SUBJECT: SUPPORTING DOCUMENTS - G. WALLIS'S DISCUSSION
ON STATUS OF EPRI RETRAN-3D CODE REVIEW - 465th
ACRS MEETING, SEPTEMBER 1, 1999

MEMO TO: Farouk Eftawila
FROM: Joseph M. Kelly
SUBJECT: RETRAN-3D REVIEW

As part of NRR's review of the RETRAN-3D thermal-hydraulic analysis code, I was asked to review the two-phase flow models with specific emphasis on the Chexal-Lellouche drift flux model. This memo serves to document the results of my review.

Figure II.3-8. Control Volumes for an Elbow

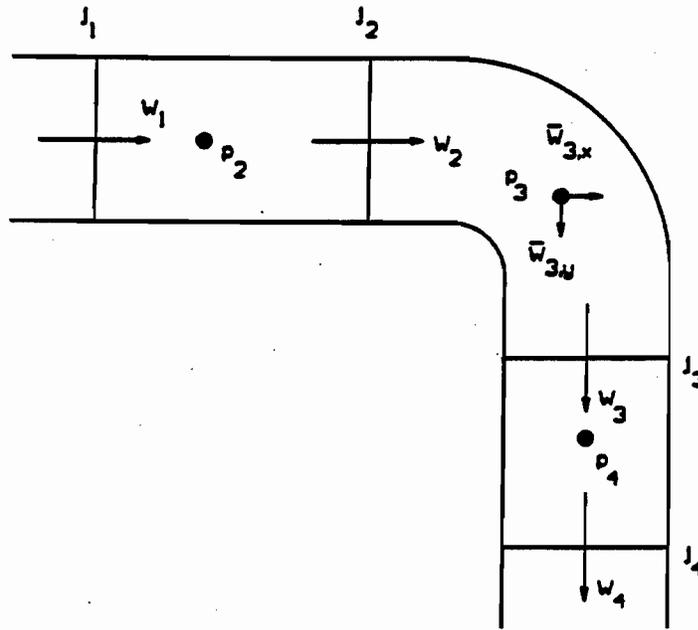
One of the points Prof. Wallis made concerned the neglect of wall forces and the implicit substitution of pressure forces to make up for it. The elbow example (see section 3.1.2.4 of Volume 1) provides a good illustration of this. Note: the notation of Figure II.3-8 is used in the subsequent discussion.

discrepancy Prof. Wallis noted emerges. Using the 3 volume example of Figure II.3-8, where volume #2 is upstream of the elbow, volume #3 is the elbow, and volume #4 is downstream, we see that (in the absence of irreversible losses and with constant density) there is a pressure recovery between volumes 2 and 3 followed by an off-setting pressure loss between volumes 3 and 4. Specifically,

$$\Delta P_{2,3} = \frac{3}{4} \cdot \frac{W_1^2}{\rho \cdot A_1^2} = -\Delta P_{3,4}$$

Basically, it doesn't. With the above assumptions, the channel is a stream tube for which the Bernoulli equation can be applied and one can show that the pressure at the bend is the same as that at the inlet (i.e., no head loss has occurred). What has happened in the RETRAN example, as Prof. Wallis rightly concluded, is that the wall force on the fluid has been ignored, where from the linear momentum equation, for this example, the x- and y-components of the wall force on the fluid are

$$F_{w,x} = -\frac{W_1^2}{\rho \cdot A_1} = F_{w,y}$$

If these forces had been included and the differencing of the momentum flux terms introduced no error, then the pressure at the bend should equal that at the inlet and outlet.

Figure 5-10 Chexal-Lellouche (1996) Prediction vs. Weiss et al. UPTF CCFL Data

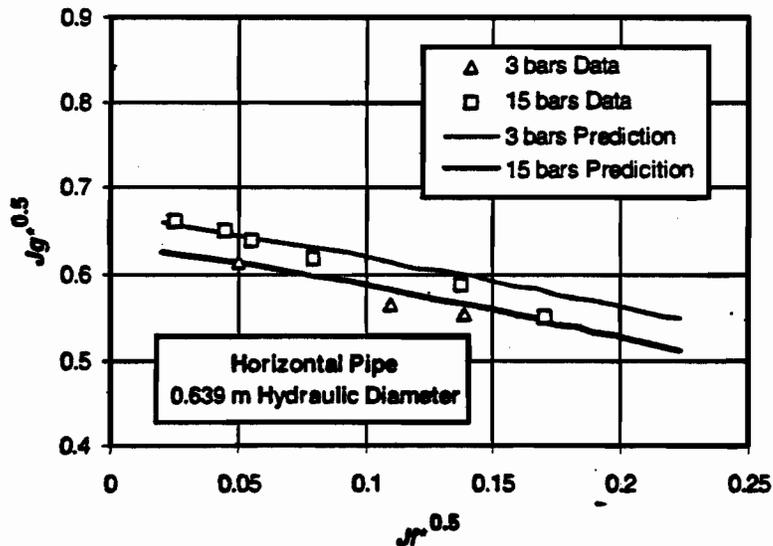
- **Pressure Dependency:** based on the data comparisons given in the Void Fraction Technology booklet, see attached Figures 5-6 and 5-10, the pressure dependency of the predicted CCFL seems to be incorrect. In Figure 5-6, which is plotted using the Kutateladze no., the pressure effect is greater over-stated in the calculation, and in Figure 5-10, plotted using the Wallis scaling, the predicted pressure trend is opposite that of the data.
